MetroLink

Transport Infrastructure Ireland

Chapter 9 Erratum

ML1-JAI-TRA-ROUT_XX-RP-Z-00002 | P01.1

Diagram 9.20: Do Minimum Mode Share in AZ3 Dardistown to Northwood Section

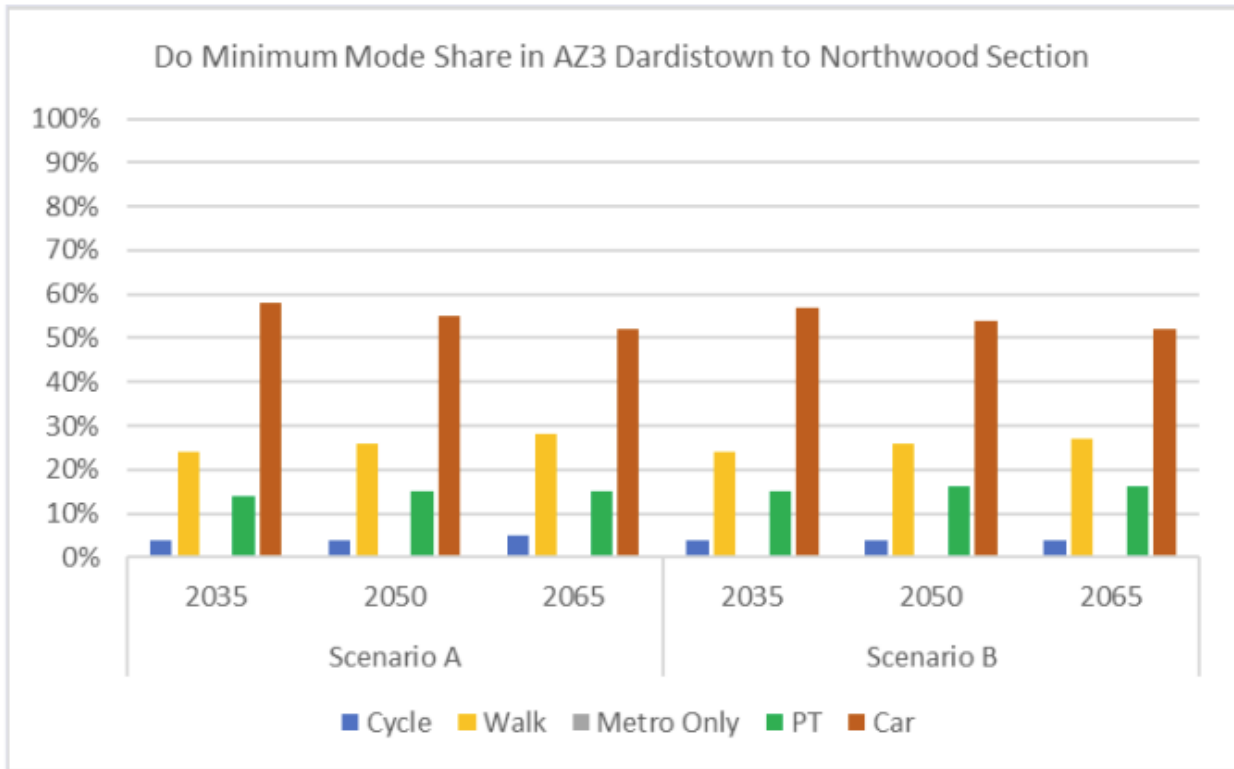
An error occurred when inserting diagrams and their labels into the EIAR, the label '*Diagram 9.19*' was accidentally inserted twice, the first time on page 59 and second on page 60. As a result, all diagram numbers beyond the diagram shown below, are captioned incorrectly and the in-text reference does not correlate to the image the text describes.

An example the incorrect labelling is shown here:

The text here references *Diagram 9.21* whilst the diagram is labelled *Diagram 9.20*, and the graph should be captioned *Diagram 9.21*.

This should be taken into consideration from page 59 onwards.

A.1 Figures 9.30 – 9.35

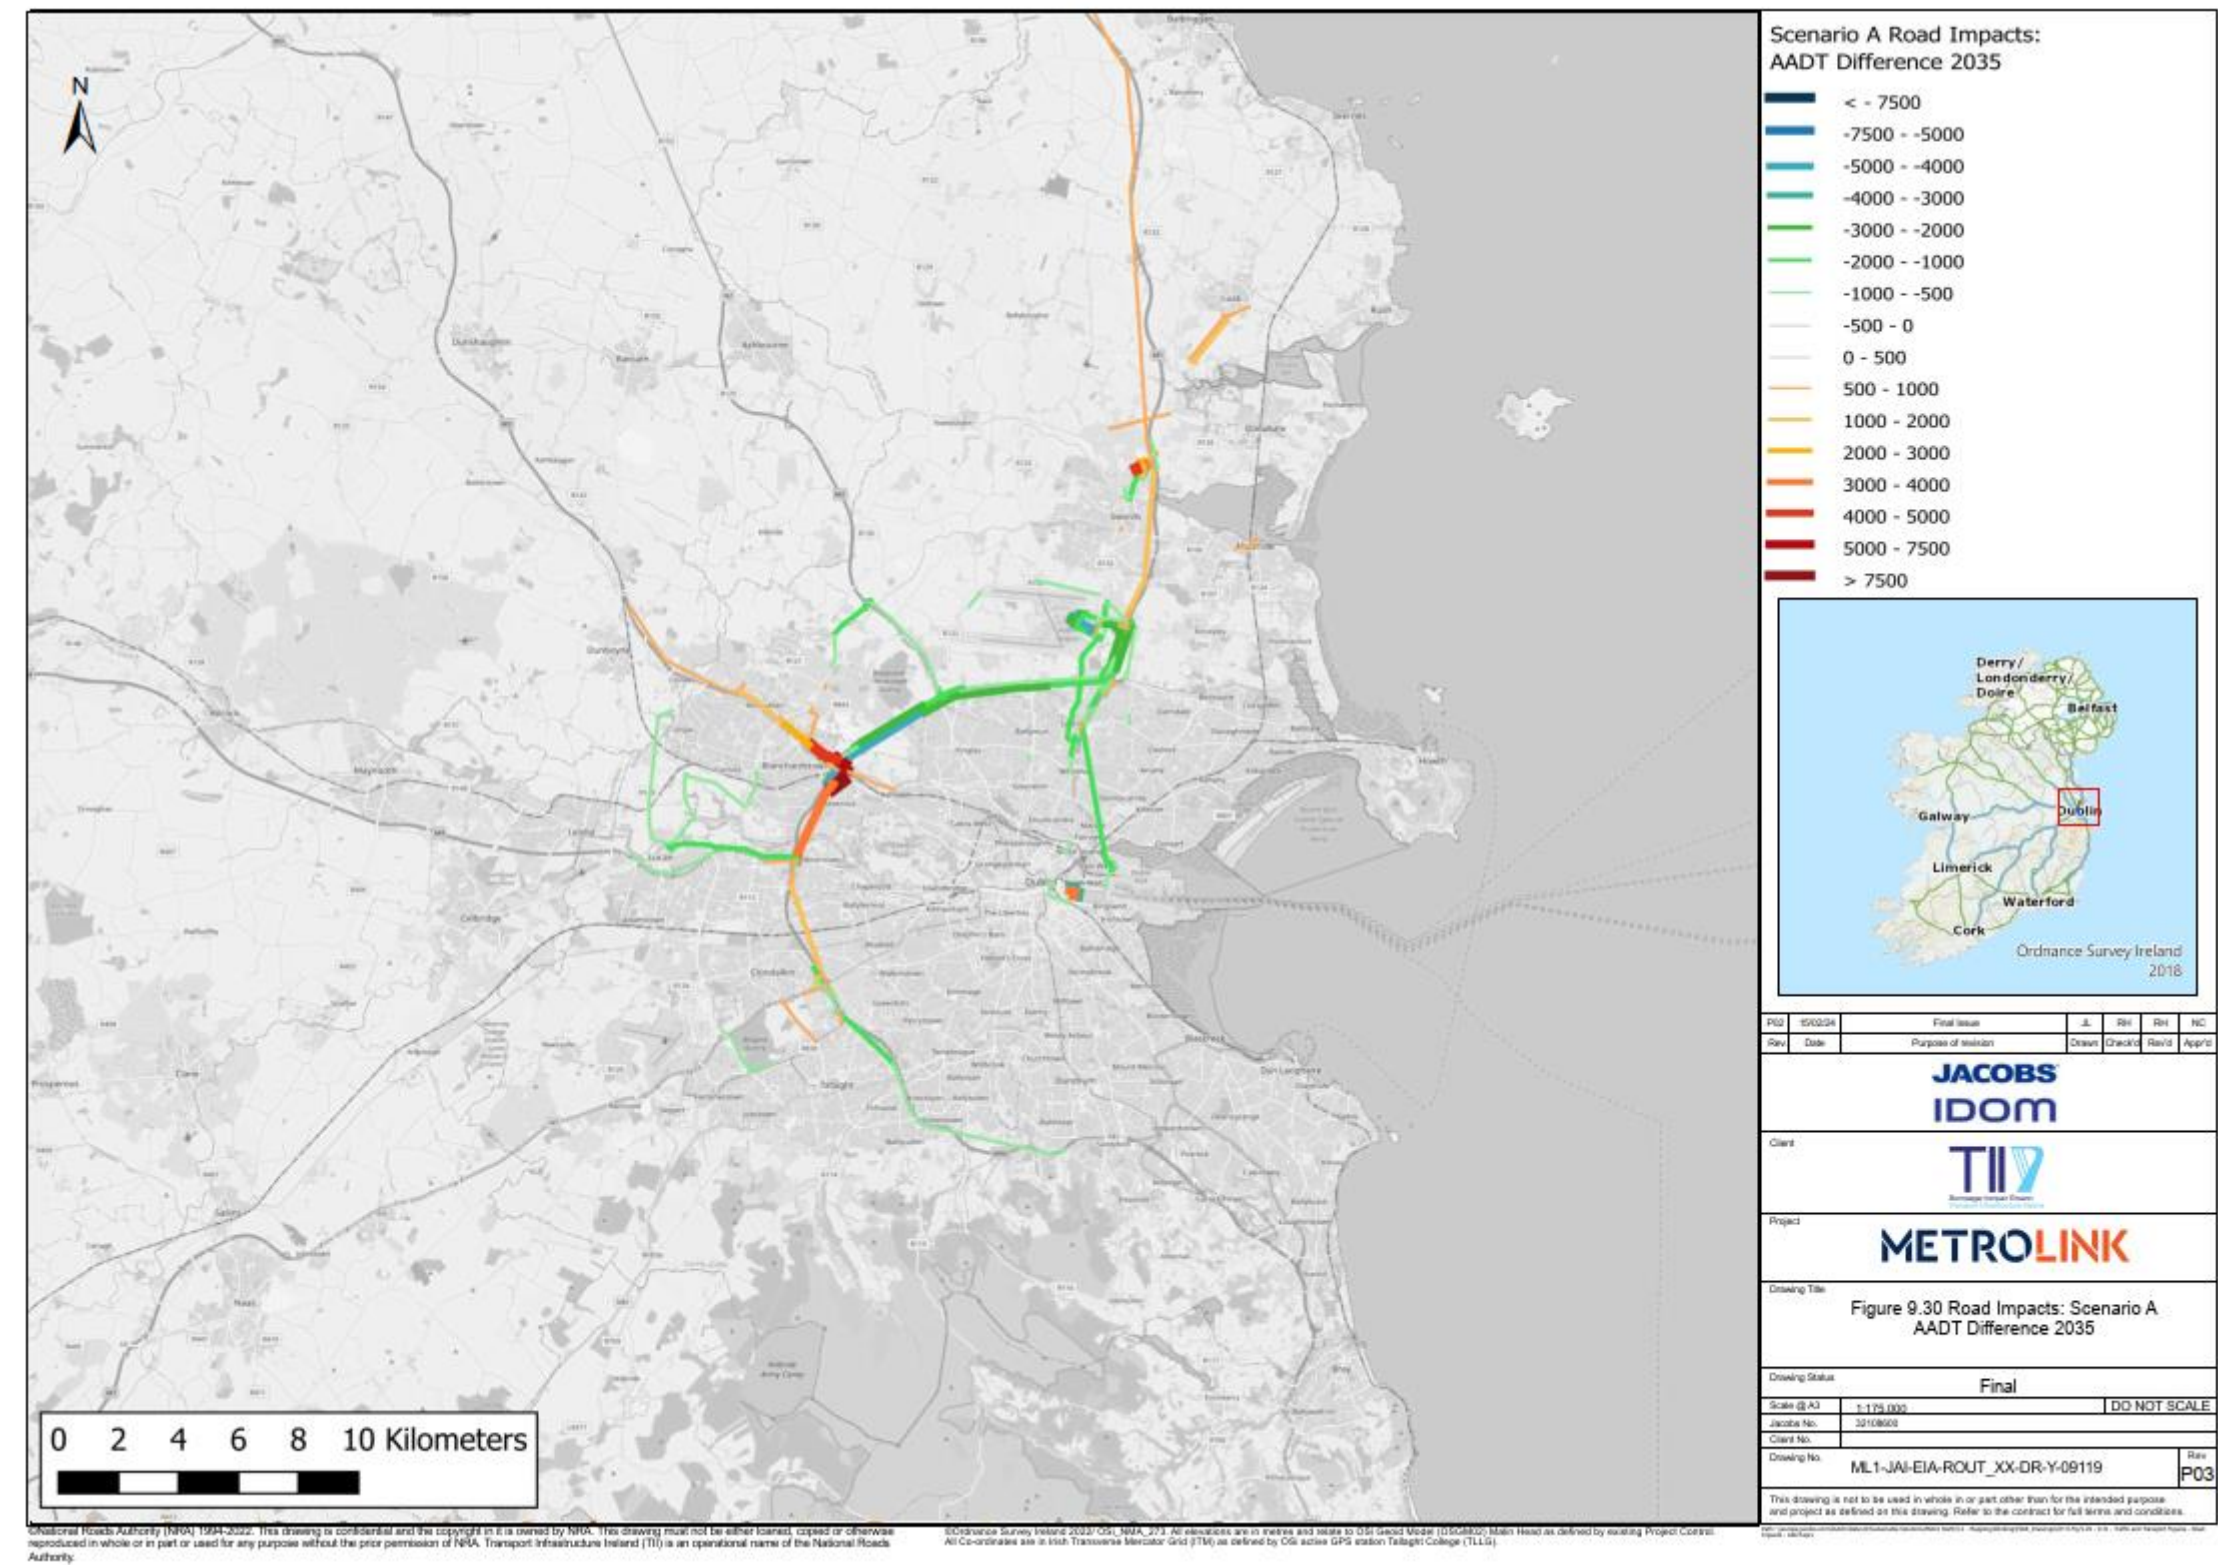
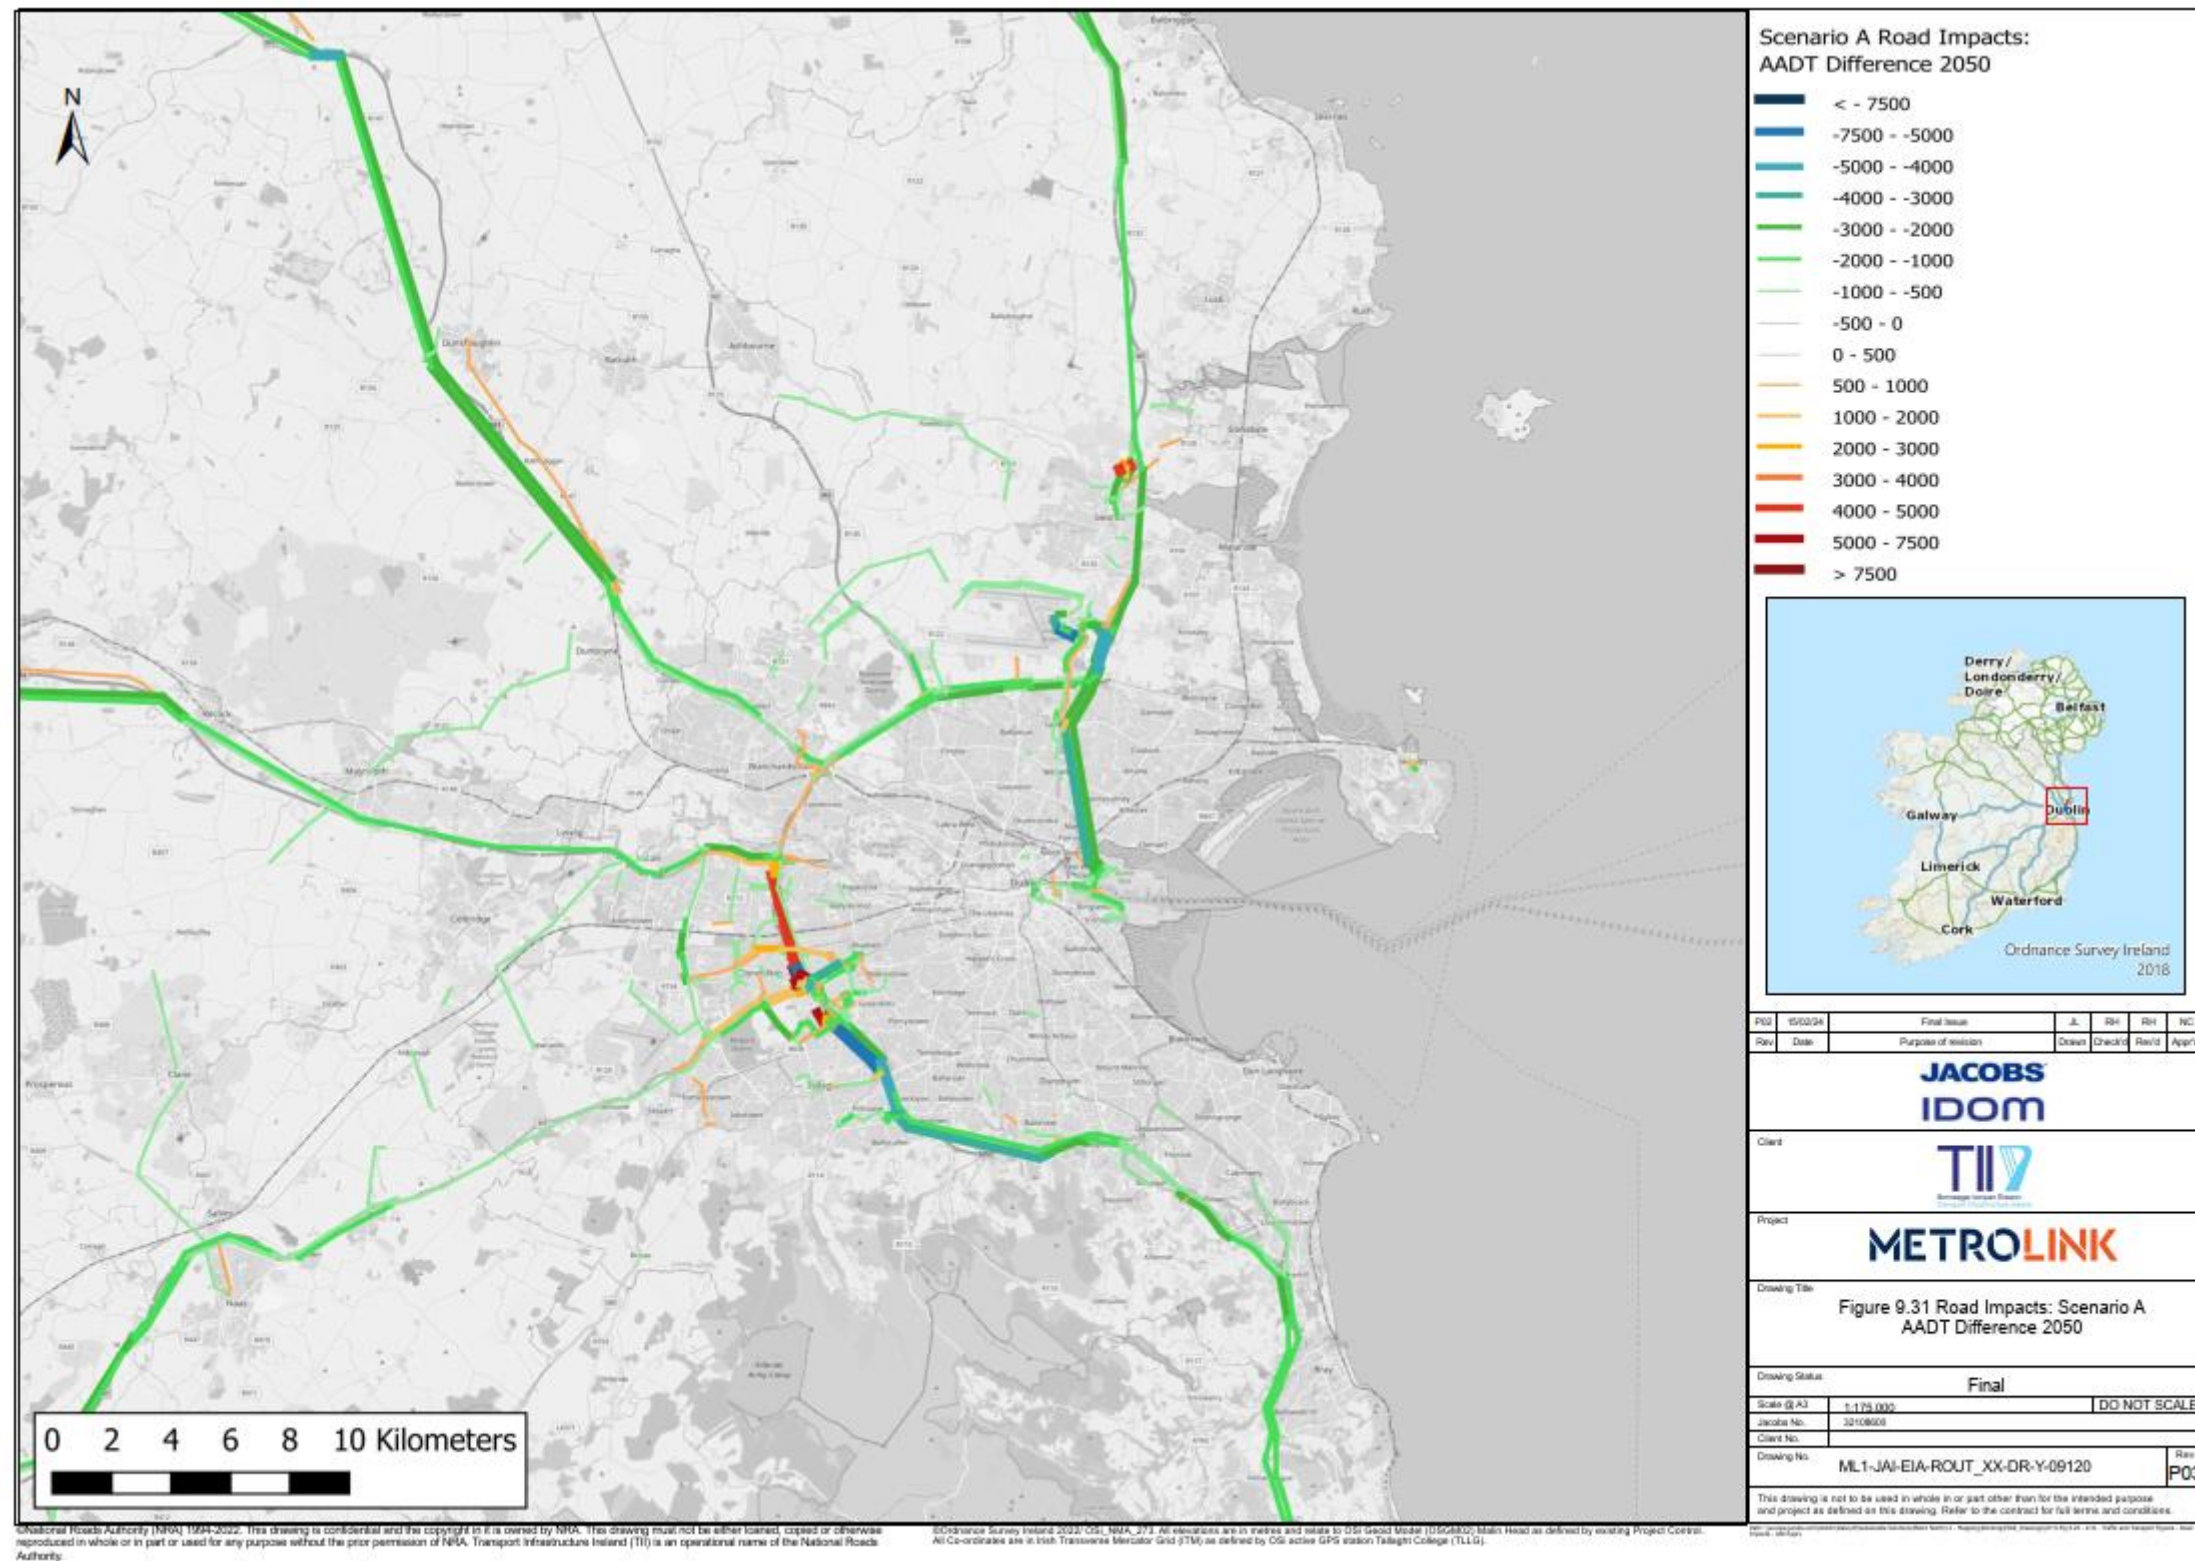
1.2.1 Reason for Change - Updates to Figures 9.30-9.35

The figures initially presented in the EIAR did not present the information in a clear and easy to understand manner. As a result, the images have been reproduced using the same information as before but using a different colour grading scale. Images are in the appendix below.

The below figures are the updates maps for figures 9.30 – 9.35 within chapter 9 of the EIAR.
